**Council Response to Request for Advice
Upper South Creek Advanced Water Recycling Centre SSI-8609189**

**Council Response to Request for Advice - EIS
Upper South Creek Advanced Water Recycling Centre SSI-8609189**

Table one (below): Discharge locations and treatment levels with increased rainfall and stormwater ingress into the sewerage system.

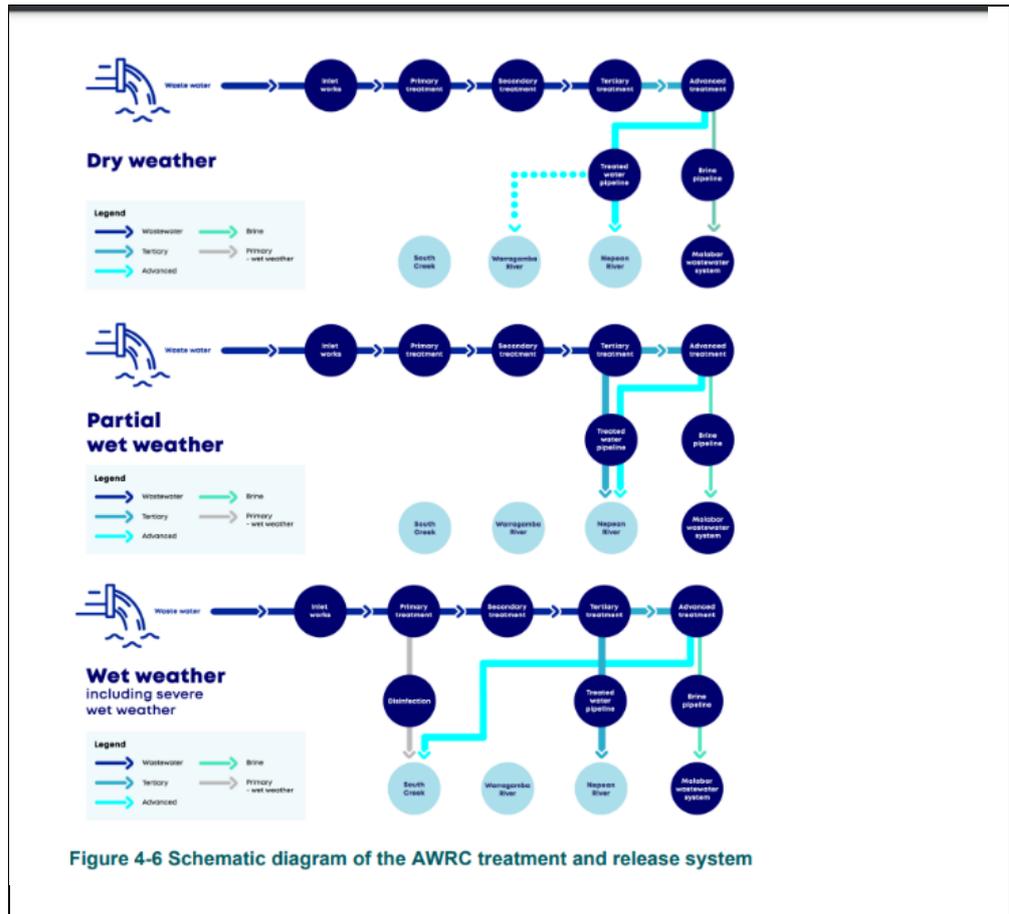
As rainfall increases, and more stormwater enters the treatment system, treatment levels decrease, and tertiary treated wastewater is proposed to be released into the Nepean River. Tertiary treated wastewater has higher concentrations of nutrients and other pollutants compared to the advanced treated wastewater. When influent flows into the treatment plant reaches 3 times the average dry weather flow it will be primary treated and released into South Creek. Primary treatment is the lowest level of treatment and is basically just the screening out of solids.

Council raises that further options are to be explored include releasing the advanced treated wastewater into Boundary Creek at Penrith where the St Marys Advanced Wastewater Treatment System already releases or alternatively directing the wastewater to the St Marys plant itself.

The two images below show the proposed pipeline route intersecting the Conservation Lands and the second shows a Nearmap Aerial imagery that shows the perimeter of disturbance (shown in red outline) compared to the proposed pipeline route (shown in yellow).

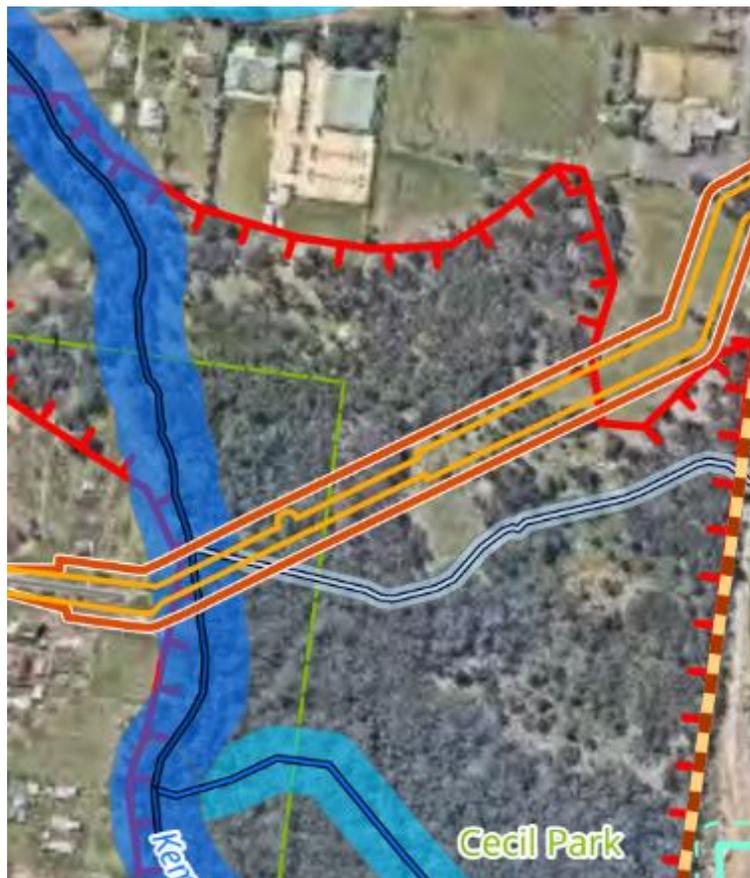
By locating the pipeline in this already disturbed footprint this will avoid/reduce clearing of native vegetation and impacting on threatened flora and fauna species habitat.

Figure 4-11 Difference in 1% AEP Flood Levels Between AWRC Model and WorleyParsons (2015)

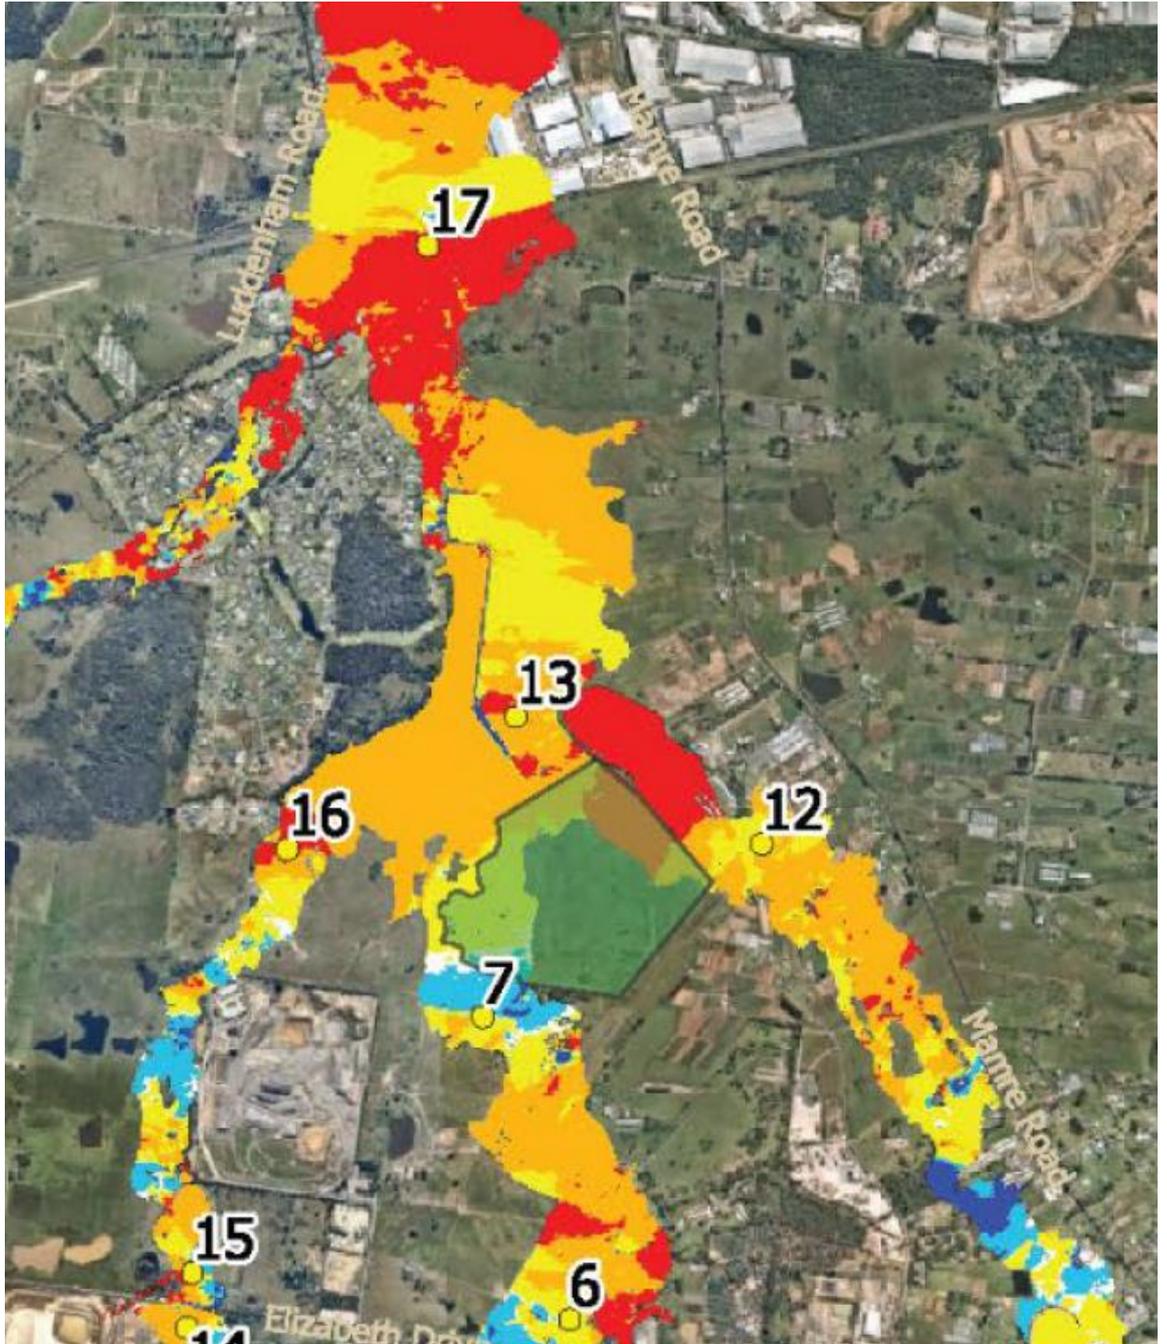
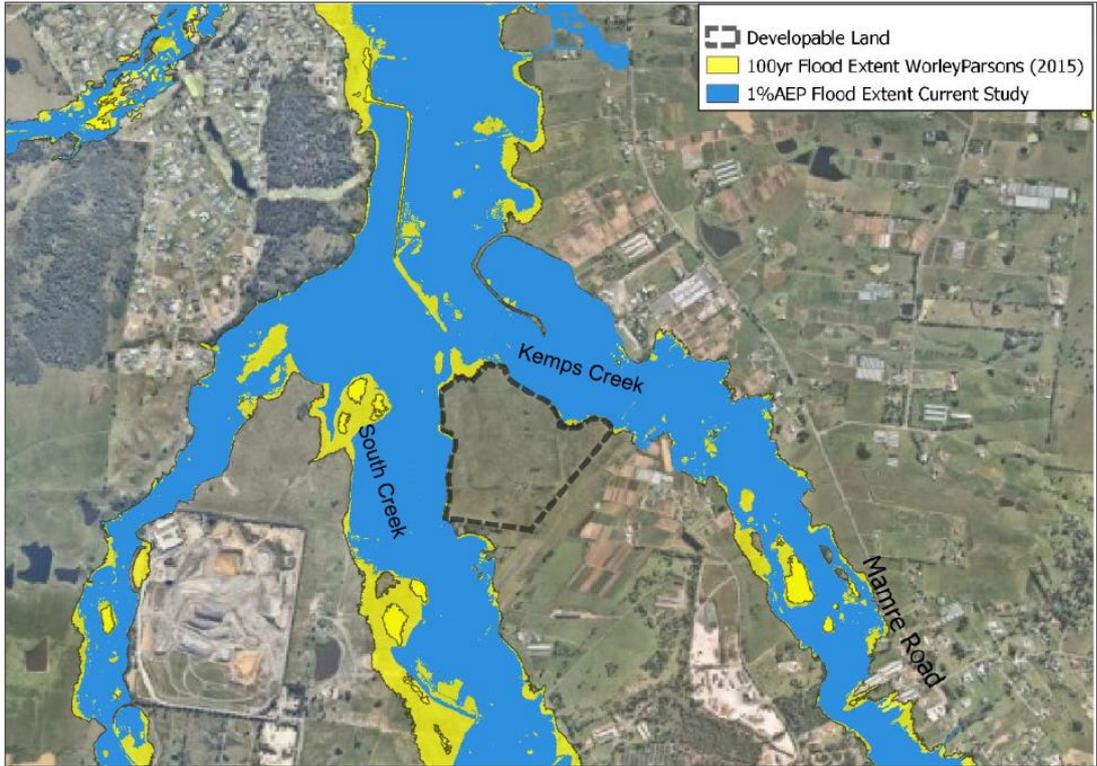
- For existing scenario and using ARR1987 procedures, the comparison of the 1%AEP flood levels in Section 4.4.7, Table 4.7 and Figure 4.11 shows that the AWRC TUFLOW model results are slightly higher than the adopted Council 1%AEP flood levels. The difference is in the range of 200 mm to 300 mm.

- Figure 6.3 shows that the 1%AEP flood extent from WARC TUFLOW model is narrower than the adopted 1%AEP flood extent from Council adopted South Creek FS 2015. The results presented in Figure 4.11 are not compatible with the results presented in Figure 6.3 using the same WARC TUFLOW model.

Figure 4-13 Comparison of flow estimation methods at Mulgoa Rd Gauge (WMA Water, 2019)

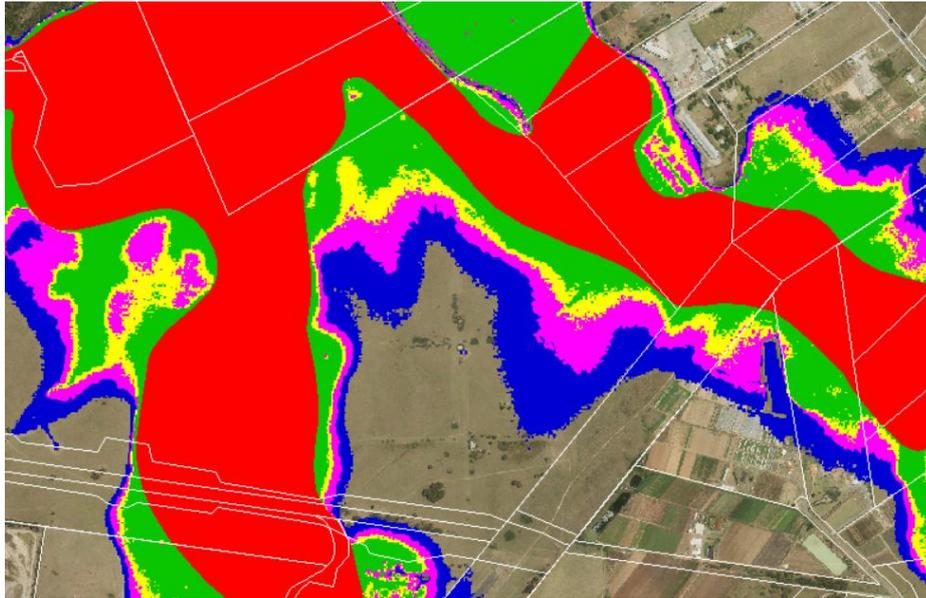
- Figure 4-13 and Table 4-8 of Appendix L Part 1 show that the modelled flows in this study are close to the lower boundary (green line) of the 90% Confidence Limit envelope using the ARR2016 procedures. Table 4-8 shows the WARC TUFLOW modelled South Creek flowrates upstream of Elizabeth Drive for different design storm events. The table clearly shows that the modelled flowrates for all design events are well below Council adopted South Creek FS 2015.

South Creek FS 2015: Magenta FPA, Blue PMF and Red-Green-Yellow Hydraulic Categories

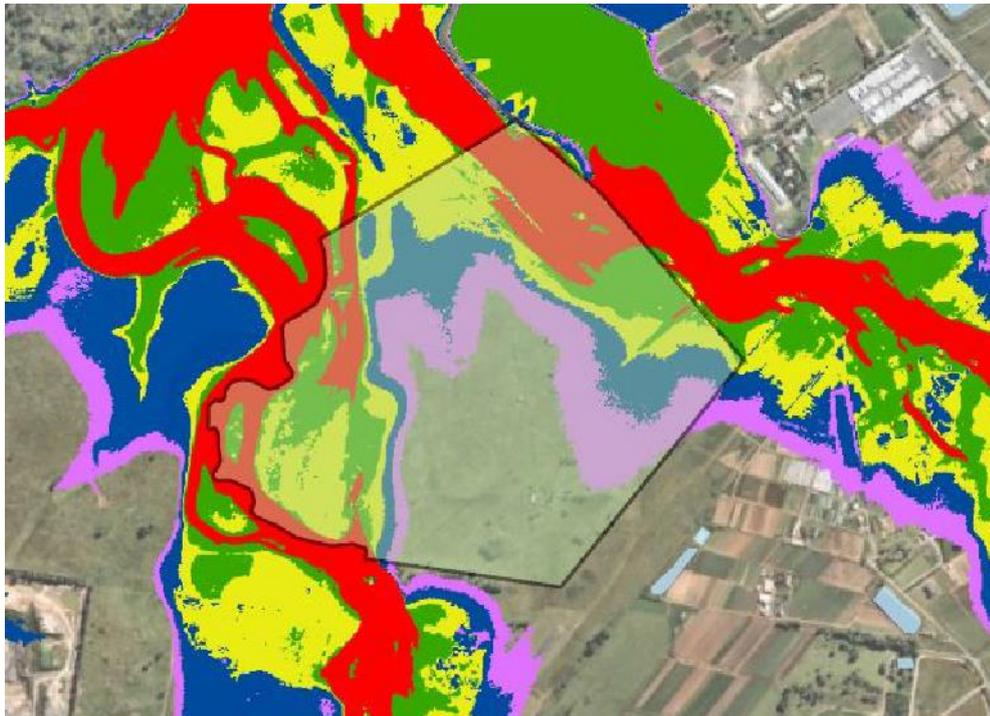
- The hydraulic categories presented in Figure 6-30 are not consistence with the hydraulic categories mapped on Council adopted South Creek Flood Study Worley Parsons 2015. The heading of this figure is misleading and incorrect. This issue needs to be rectified. The Figure shows the hydraulic categories based on the parameters listed in Table 6-4 as part of Sydney Water WARC FIA.
